## CITY OF SAINT PAUL

## All Comments Received from Charette Follow-up

**TABLE #1** **VICTORIA PARK**

**TABLE #5**  
Saint Paul Parks and Recreation

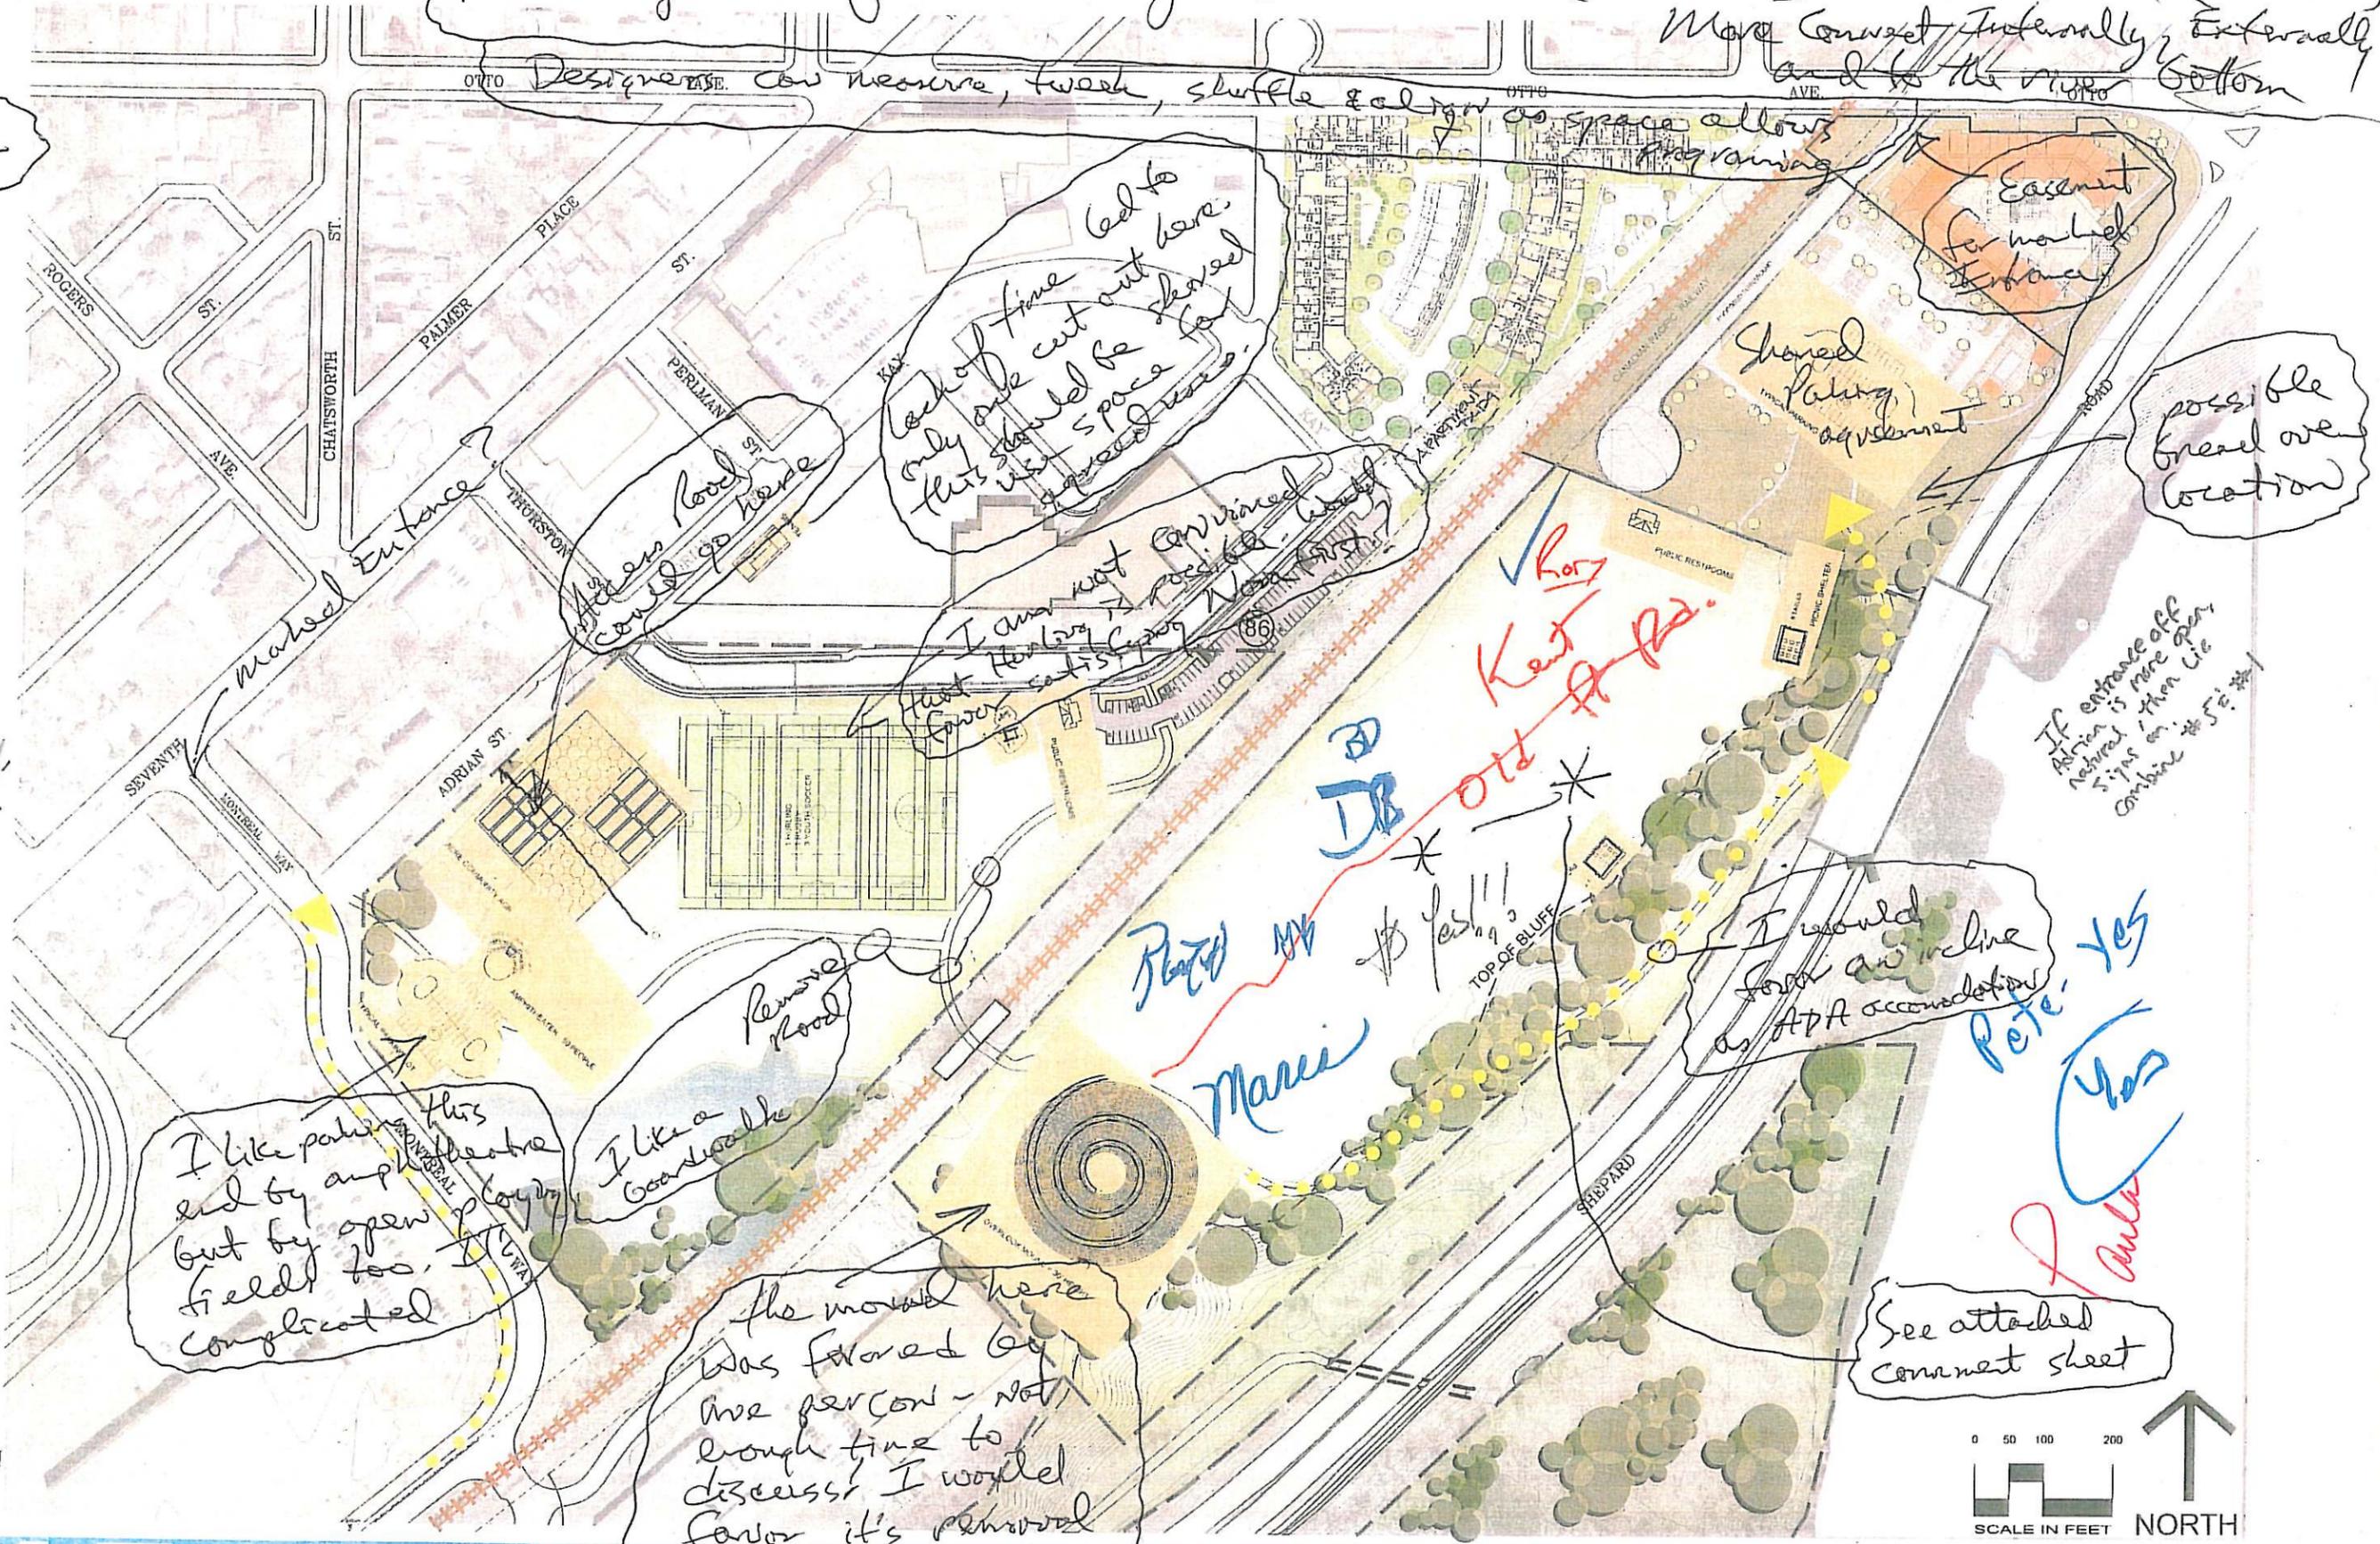
I prefer 'Big Idea' of GRP to guide More Urban (North section) More Natural (south section) More Connected Internally, Externally and to the rest of the city Bottom

- winter use
- design w/ water
- natural landscaping, rain gardens
- urban
- natural
- education opps.
- pkg. for park users
